**NHTSA Recall No. 24V-934
Cummins Campaign #C5807
2nd Notice**

IMPORTANT SAFETY RECALL

This notice applies to your Cummins Power Generation C275D2RE Generator Sets listed in the table on the enclosed generator set list.

Figure 1: Inspection Location on Generator Set

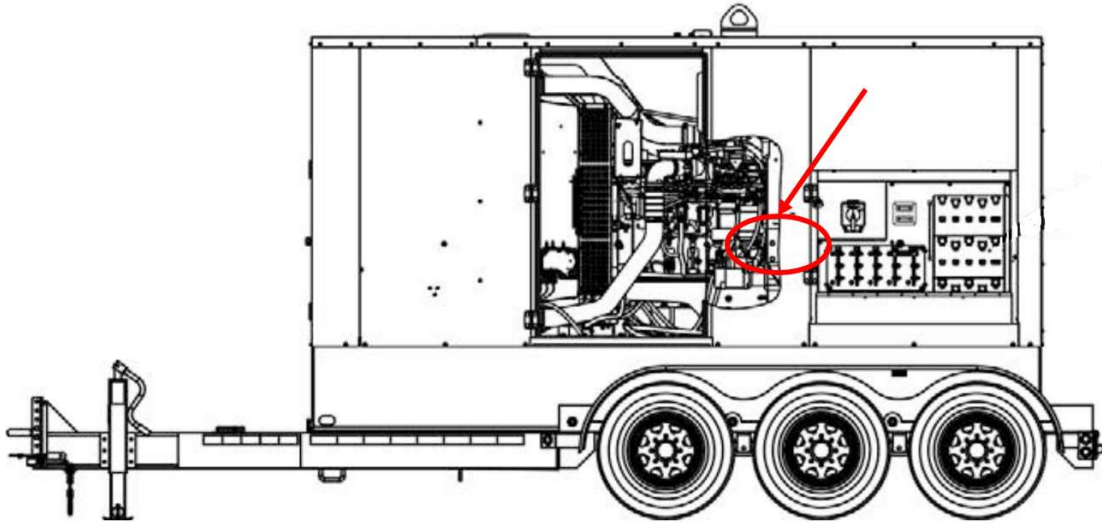
3. Locate the engine's starter motor and inspect the nearby red wires with fuse holders outside of the protective loom for signs of chafing or damage. The inspection location is illustrated in Figure 1.

Figure 2: Example of exposed red wires touching the terminal stud of the starter motor, and resulting chafing damage

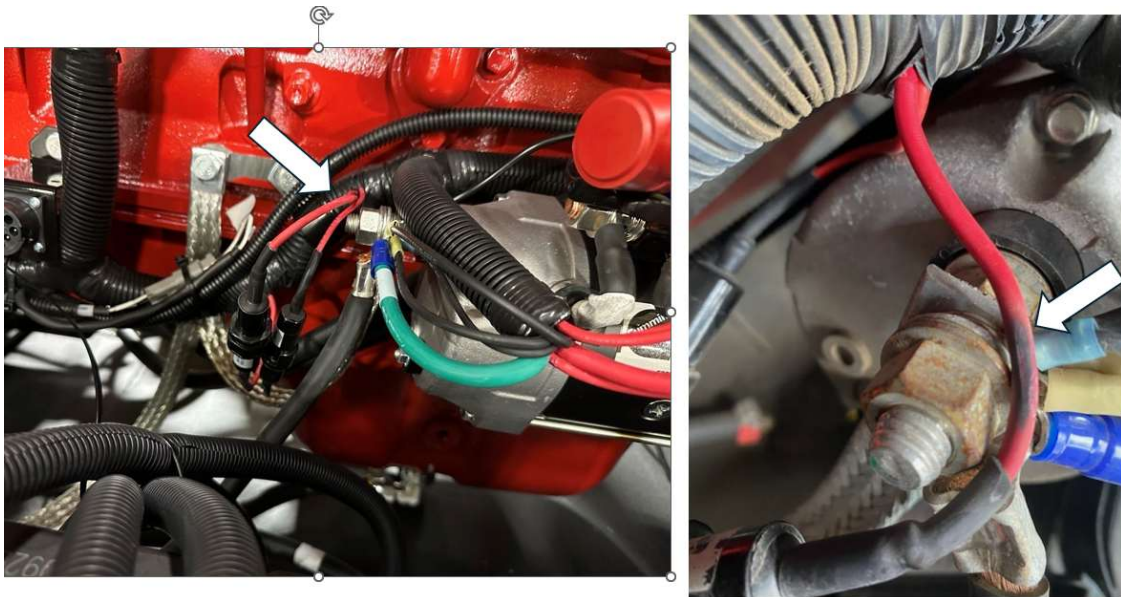
4. If the red wires are touching the housing or terminal stud of the starter motor, or if the red wires show signs of chafing or damage, DO NOT use the unit until repaired by a certified Cummins repair facility. An example of the exposed red wires touching the terminal stud of the starter motor, and the resulting chafing damage to the wire insulation, is shown in Figure 2. An example of the exposed red wires touching the housing of the starter motor is shown in Figure 3.
